HISTORIC PRESERVATION COMMISSION AGENDA ITEM EXECUTIVE SUMMARY			
		Agenda Item Title/Address:		COA: 402 N 4 th Ave	
		Proposal:		Single Family Home	
		Petitioner:		Chris Vieau/ Silverthorne Homes	
		Please check appropriate box (x)			
		PUBLIC HEARING		MEETING 4/3/19	X
AGENDA ITEM CATEGORY:					
<input checked="" type="checkbox"/>	Certificate of Appropriateness (COA)			Façade Improvement Plan	
	Preliminary Review			Landmark/District Designation	
	Discussion Item			Commission Business	
ATTACHMENTS:					
COA Application					
2/6/19 Meeting Minutes					
Site Plan					
Design Drawings					
EXECUTIVE SUMMARY:					
<p>Proposed is a new ranch home designed in the craftsman style on a vacant lot off of N 4th Ave. The lot is located behind 407 N Park Ave.</p> <p>This property was discussed at the 2/6/19 Meeting, and the designs were generally favored by the Commission, with comments mostly centered on adding more craftsman style elements.</p>

a. 402 N. 4th Ave.

402 N 4TH AVE
ST. CHARLES

A1

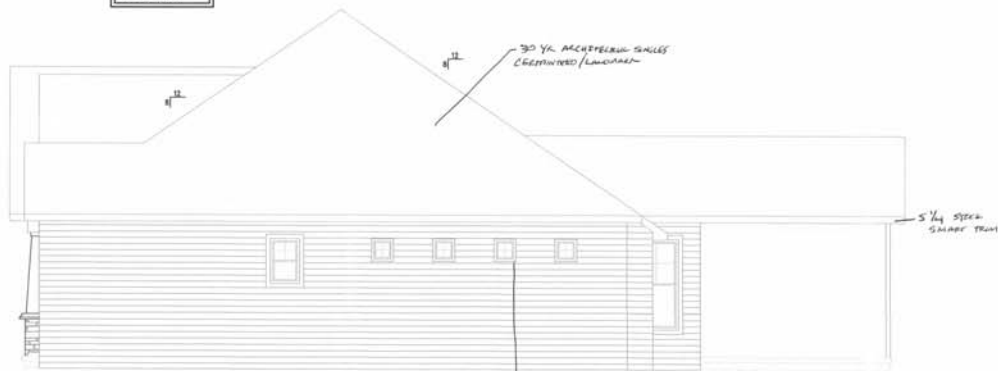
James Dulaney and Chris Vieau, the builders, were present to discuss their plans for new construction of a ranch home on a vacant lot. Dr. Smunt suggested enhancing the craftsman elements featured in the design to be more sympathetic to the historical craftsman era.
